SAFETY EVALUATION BY THE OFFICE OF NUCLEAR REACTOR REGULATION

RELATED TO AMENDMENT NO. 26 TO

RENEWED FACILITY OPERATING LICENSE NO. R-84

ARMED FORCES RADIOBIOLOGY RESEARCH INSTITUTE REACTOR FACILITY

Figure 1 – Diagram of Major Components for the AFRR Reactor Instrumentation and Control System

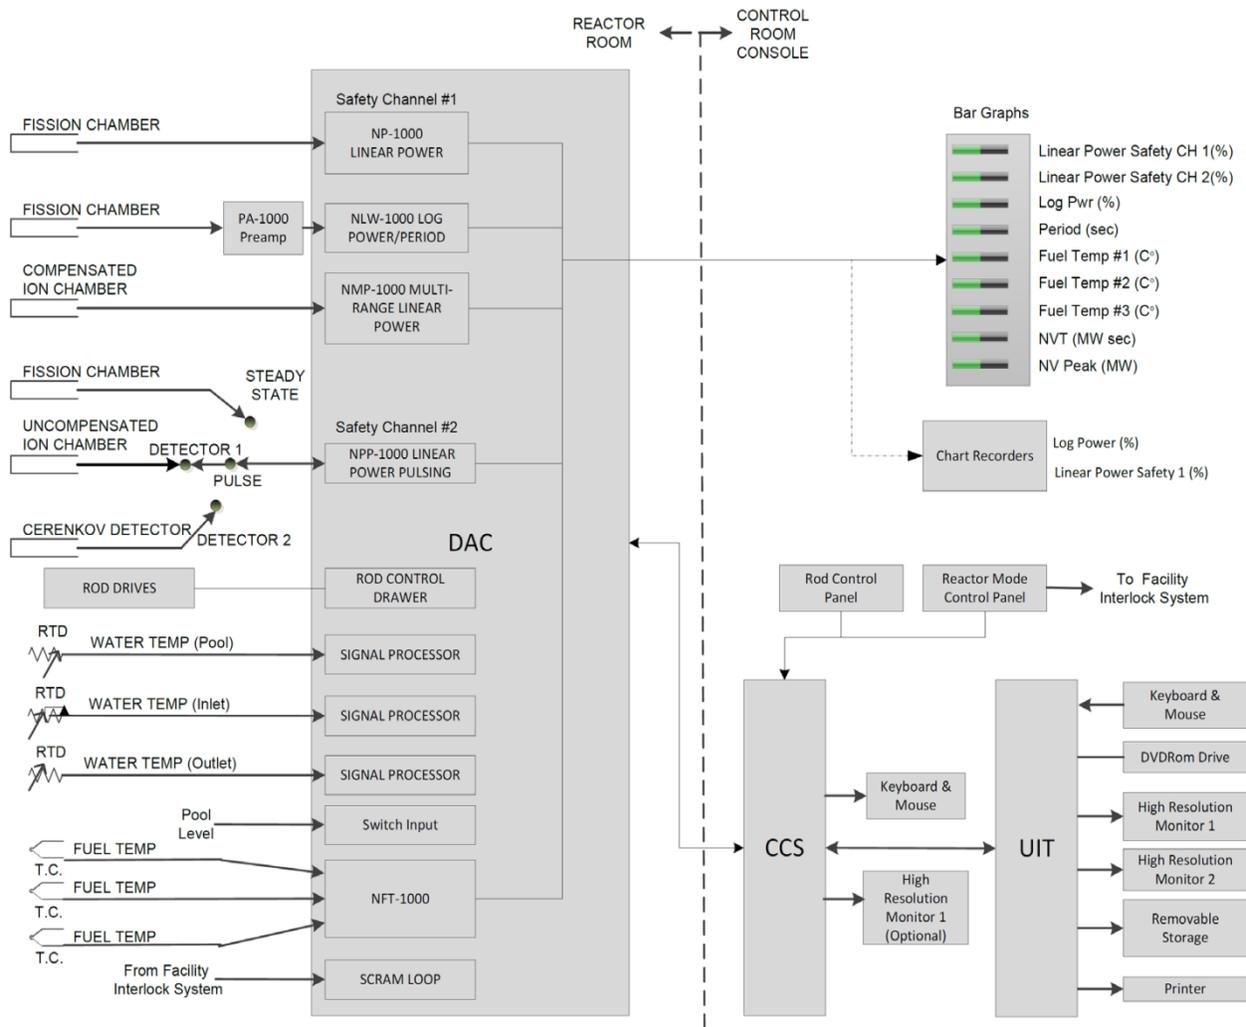
In the figure in Ref. 21, reproduced as Figure 1 below, the simplified block diagram illustrates the proposed I&C system for the AFRRI reactor. This figure identifies components that are retained and unchanged and new components that replace obsolete items.
